Project No. 2628-065  
R.L. Harris Hydroelectric Project  
Transmittal of the Final Operating Curve Change Feasibility Analysis Phase 1 Report

Attachment 2 – Comments and Responses on the Draft Operating Curve Change Feasibility Analysis  
Phase 1 Report

Attachment 3 – Final Operating Curve Change Feasibility Analysis Phase 1 Report

**Figure 5-3 Effects of Winter Pool Increases 2006-2008**

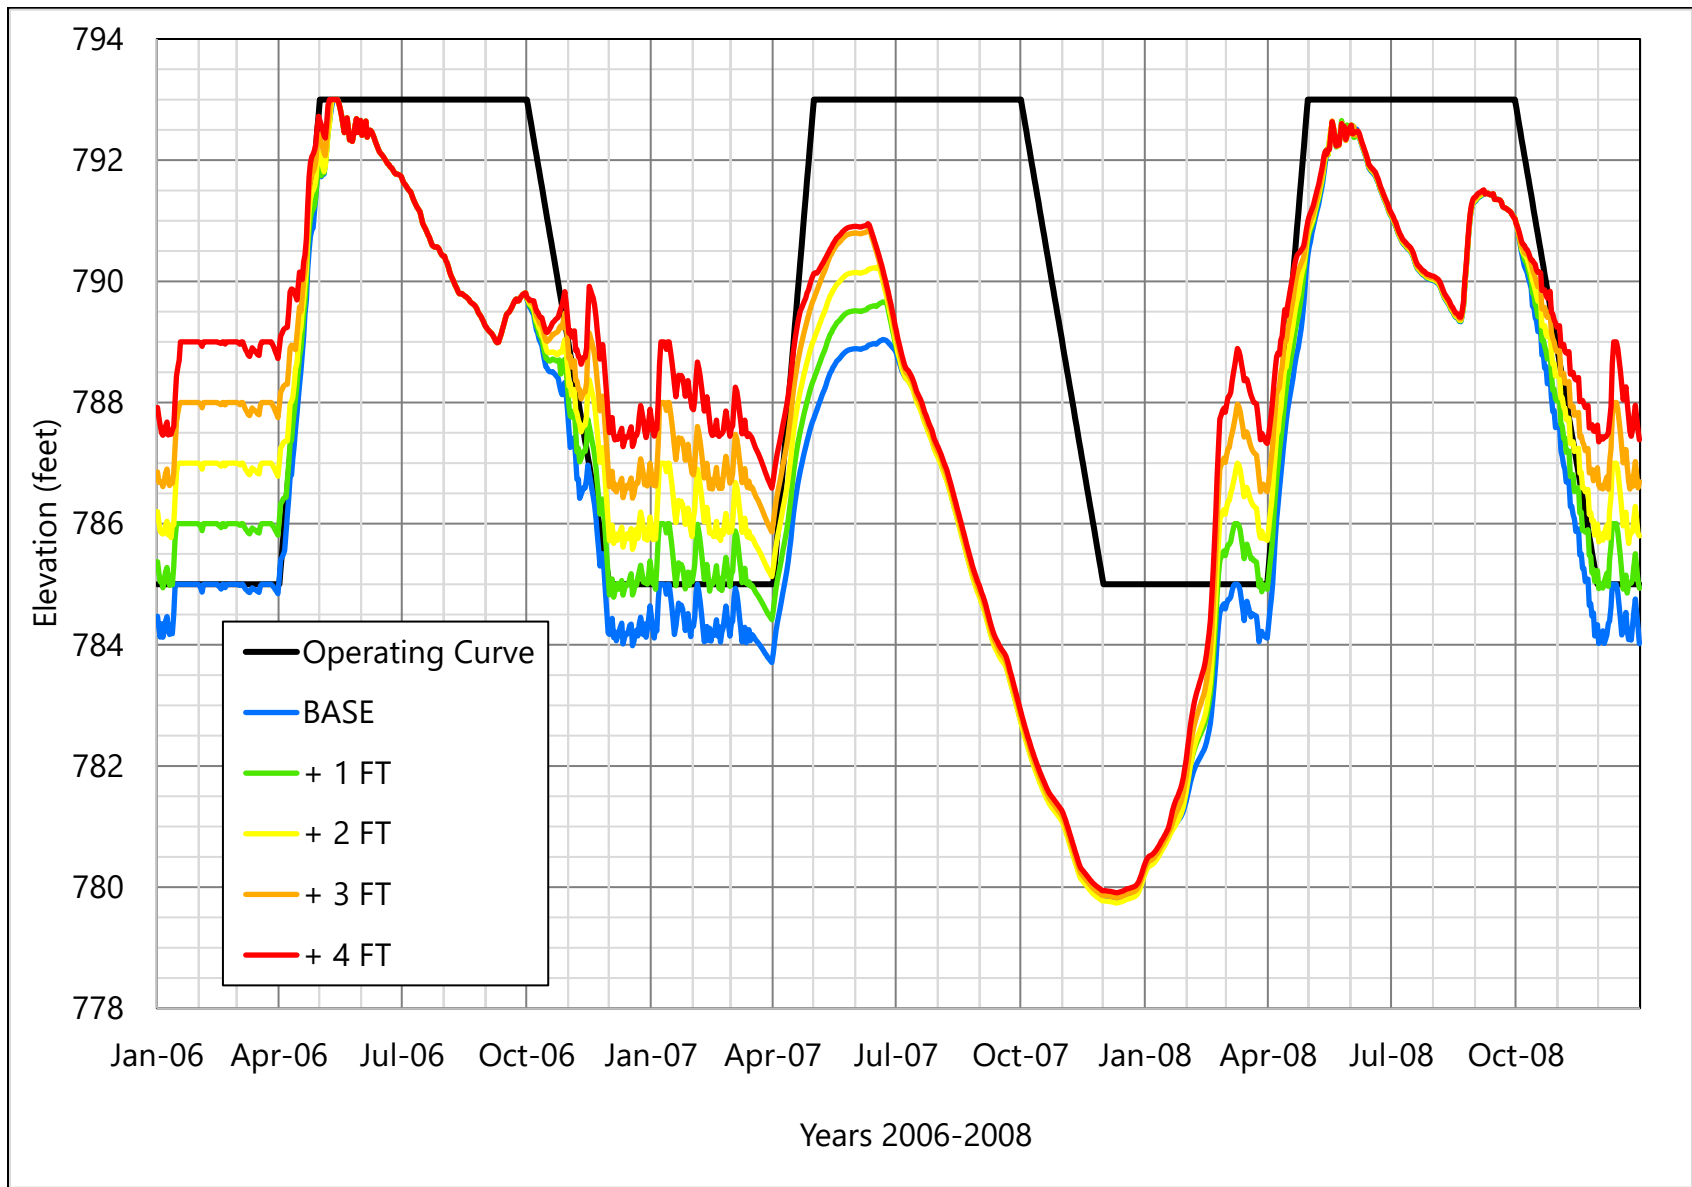
1. Figure 5-3, on page 39 of the Draft Operating Curve Change Feasibility Analysis (Phase 1) Study Report, shows how changing the winter pool elevation from the current project operating curve to the +1, +2, +3, and +4-foot winter operating curves could affect reservoir elevations in Lake Harris throughout the year. Moreover, the figure documents the interaction between higher winter pool levels and low-inflow periods. During the period between 2006 and 2008, which encompasses two low-flow periods, the model showed that increasing the winter pool elevation can result in higher reservoir elevations during low-flow years, compared to the existing operating curve. However, Figure 5-3 shows that from about July 2007 through mid-February 2008, modeled reservoir levels for the +2 and +3-foot winter pool curve alternatives were lower than that of the other operating curve alternatives for the same operating period. Please explain what appears to be an anomaly in the modeling result in the final report.

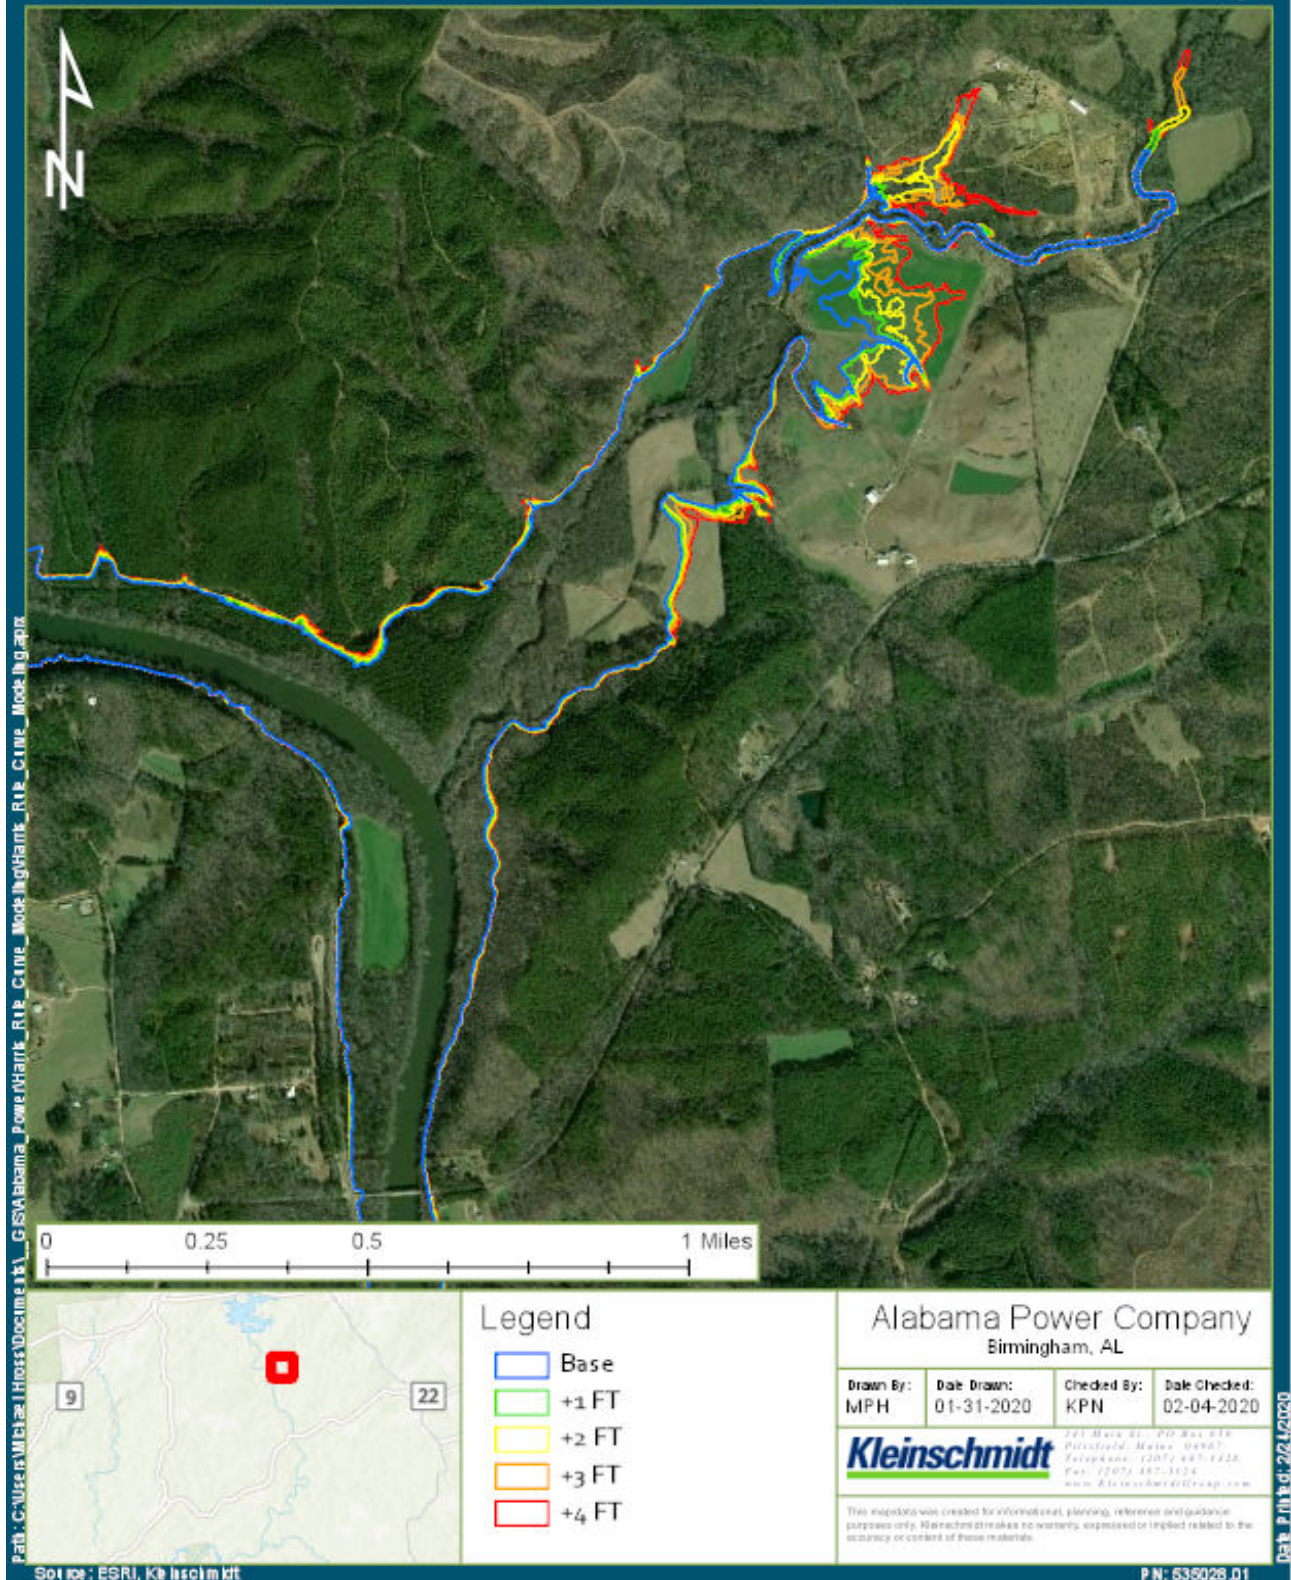
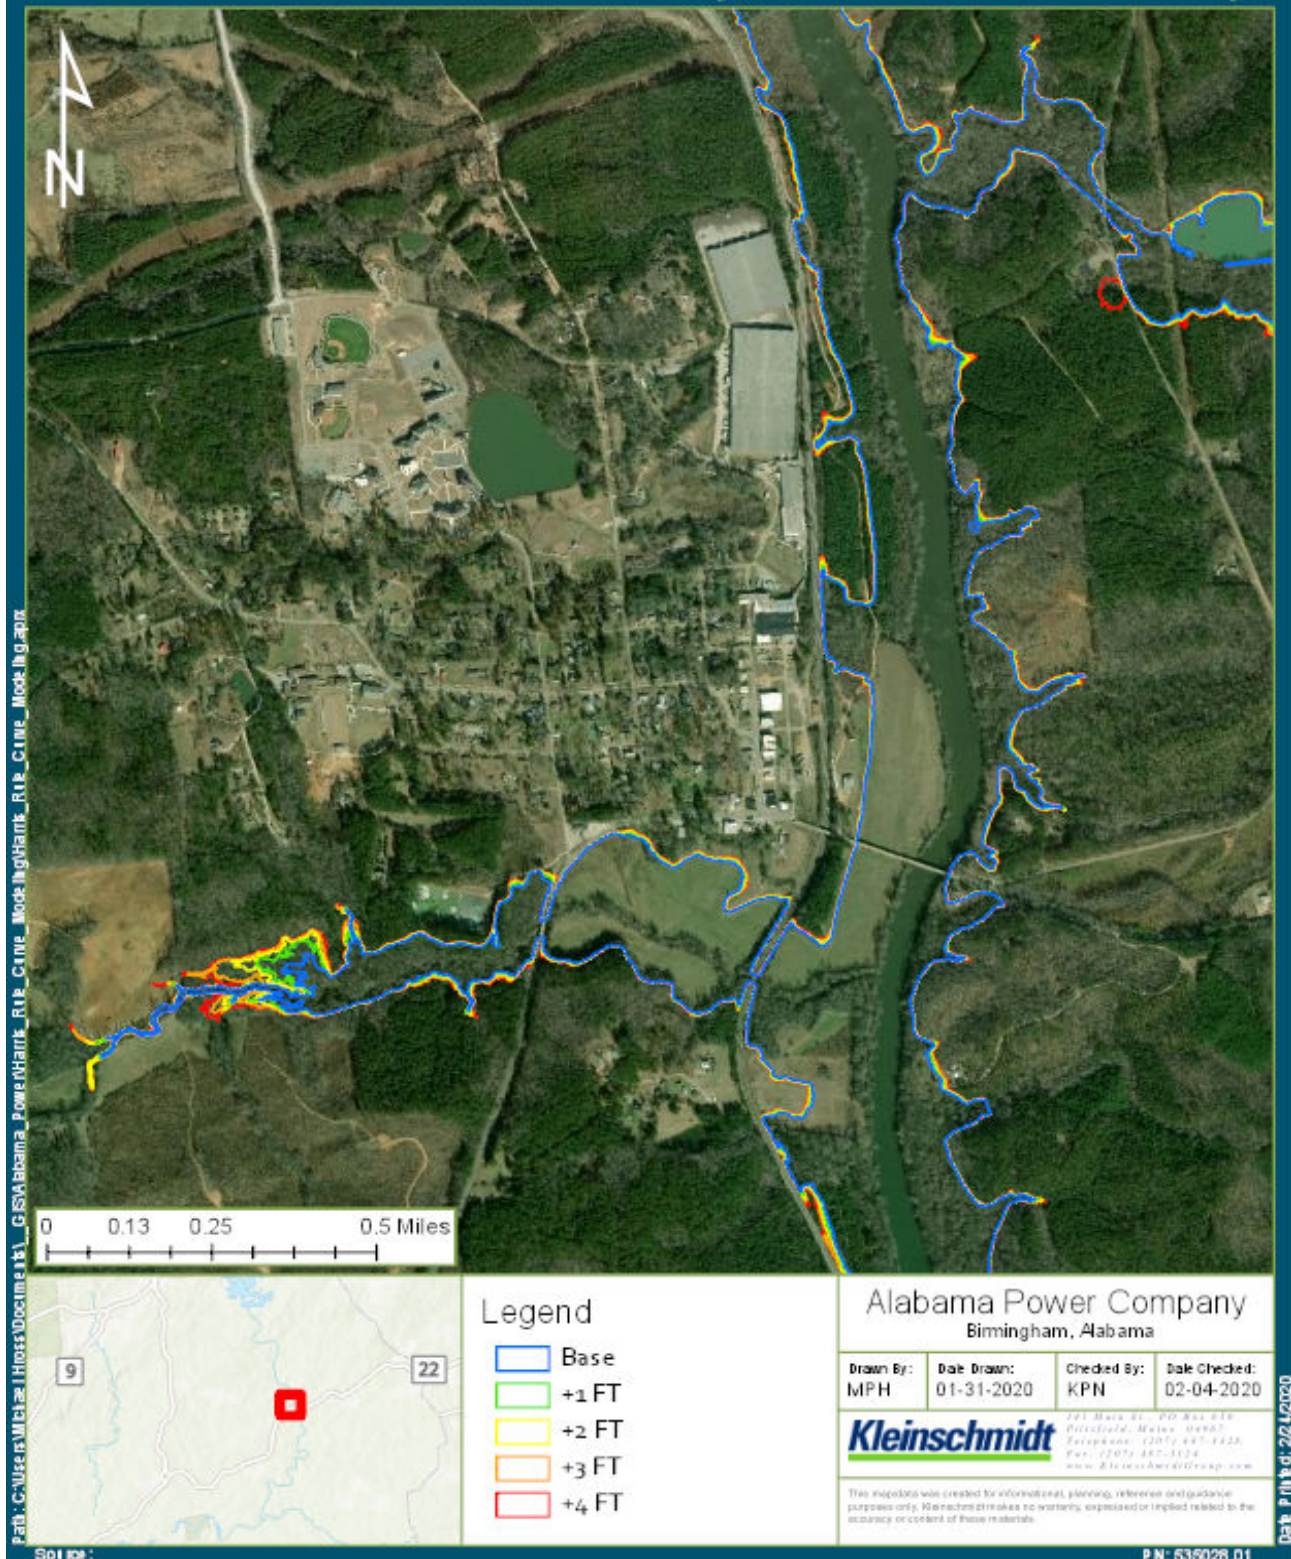
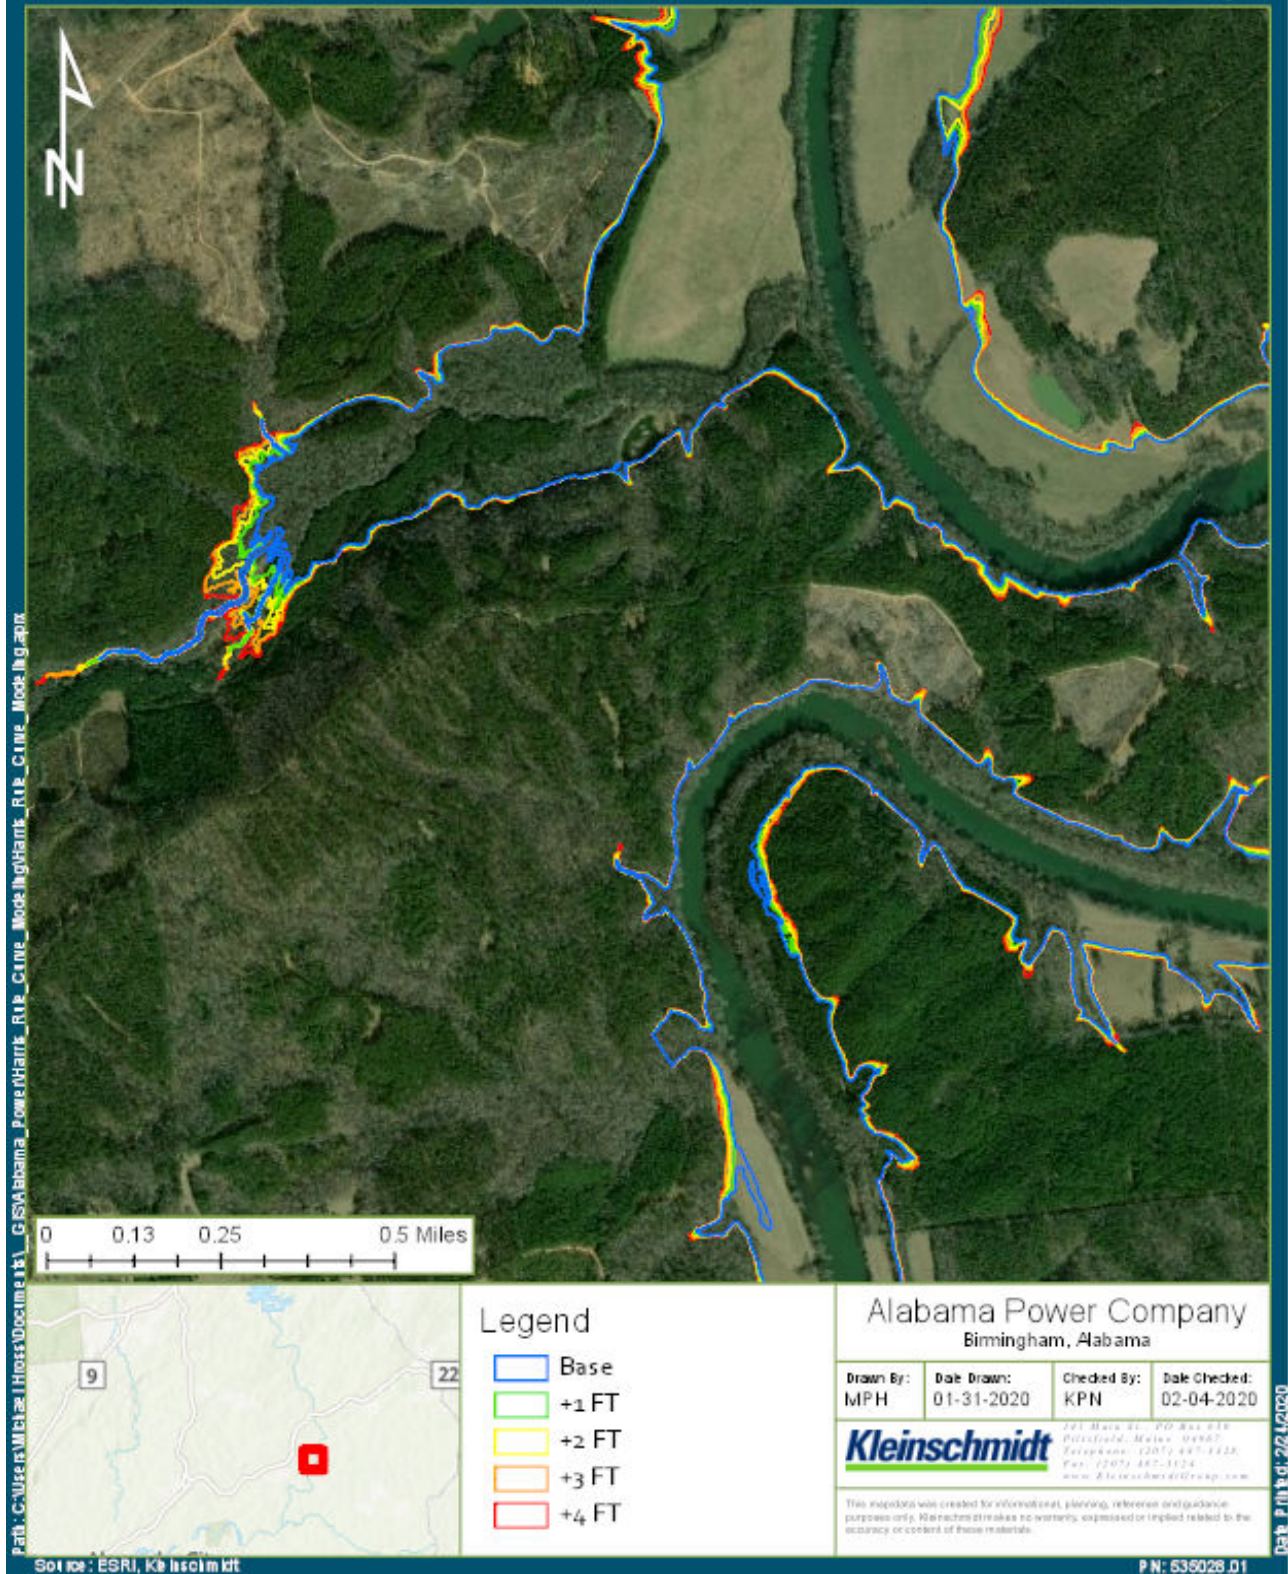
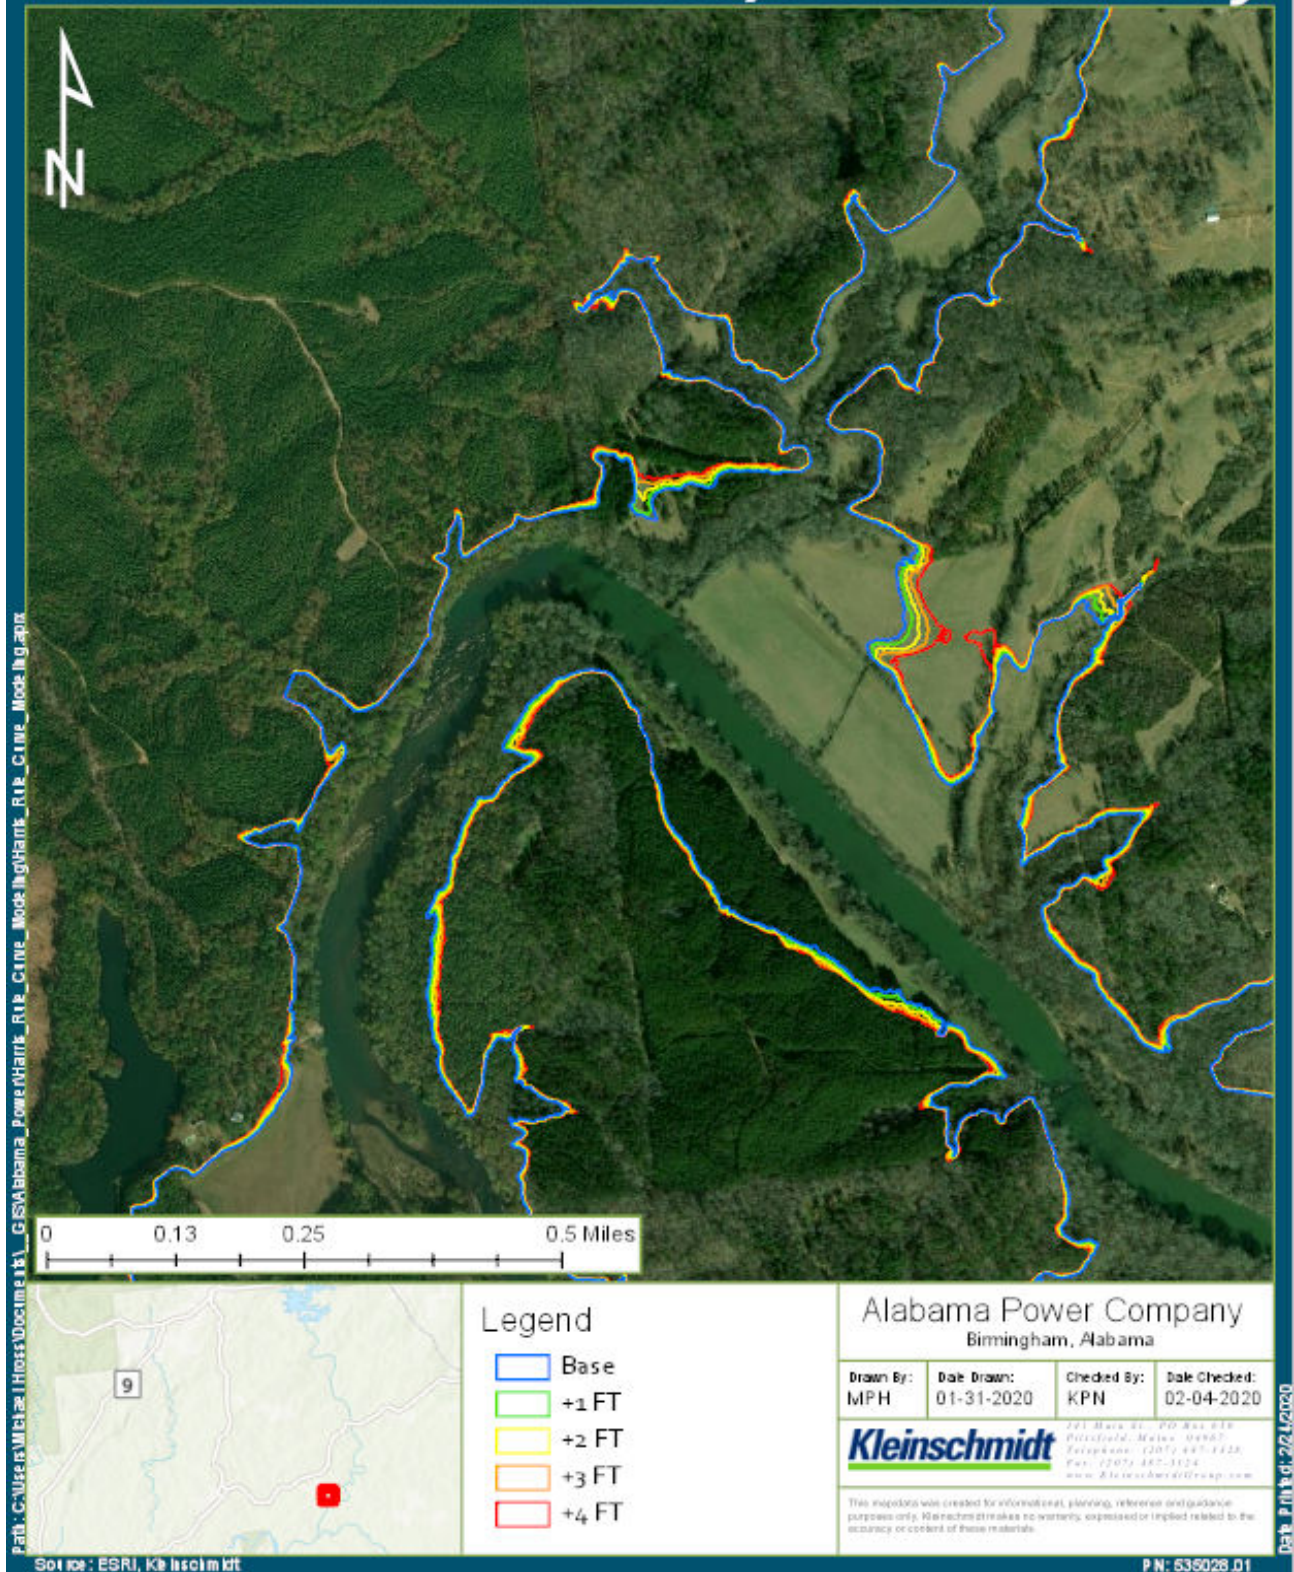
- On pages 45-50, Figures 5-7 through 5-12 of the Operation Curve Change Feasibility Analysis Study visually indicate inundation boundaries for the baseline of four winter pool alternatives. Include a Table with calculated totals of inundated acreages for the baseline and four winter pool increase alternatives to assist with the quantitative evaluation of inundation effects downstream of the dam.
